Appendix A.2

RESPONSES TO COMMENTS TO
ORIGINAL PEIR

**LIST OF PERSONS, ORGANIZATIONS, AND PUBLIC AGENCIES
THAT COMMENTED ON THE DRAFT ENVIRONMENTAL IMPACT REPORT (EIR)**

Figure 1: The presence of this deteriorated concrete channel in Switzer Canyon (**top**) has acted as a *de facto* drop structure, holding water in the creek and allowing the establishment of wetland vegetation such as willows (**bottom**).

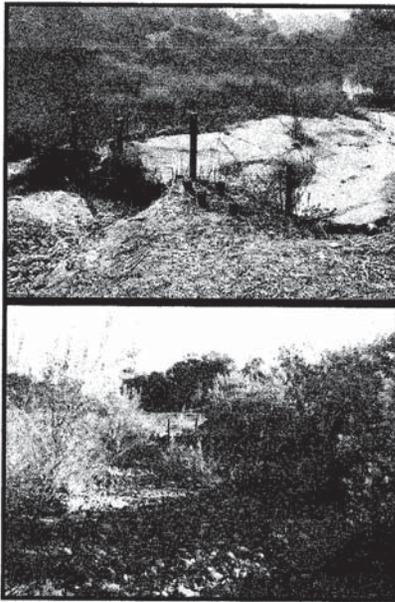
In our experience with restoration of the creek, drop structures that hold water in the flood channel are effective in keeping sediment in the Canyon where it belongs and providing a water source that is sufficient to establish robust wetland vegetation. One example is in the creek between the Balboa Park Golf Course and 30th Street (Figure 1). This area was an unvegetated channel ten years ago with a *de facto* drop structure created by past attempts to control storm water flow onto the Golf Course. Through the work of the Friends group, this area has been revegetated and has proven to support willows, which require a constant water supply. There is evidently underground water in this area that is sufficient to support wetland vegetation.

Stream erosion leading to massive sediment loss is also evident in Juniper/Chocolate canyon, which is east of Switzer Canyon and is part of the Chollas Creek watershed, upstream from Map 80. This creek has suffered from massive head cutting in the past 10 years alone (Figure 2). Stabilization of this creek and dechannelization will result in less need to maintain channels downstream.

Figure 2: Head cutting. Since 2001, this erosion in Juniper/Chocolate canyon has moved upstream more than 50 yards. The resulting gully causes storm water to flow rapidly downstream, reducing the chance of establishing wetland vegetation upstream.

L.1. The City appreciates your organization bringing potential restoration opportunities in Switzer Canyon to our attention and will consider the opportunities within the canyon during review of the IMPs within the Chollas Creek watershed.
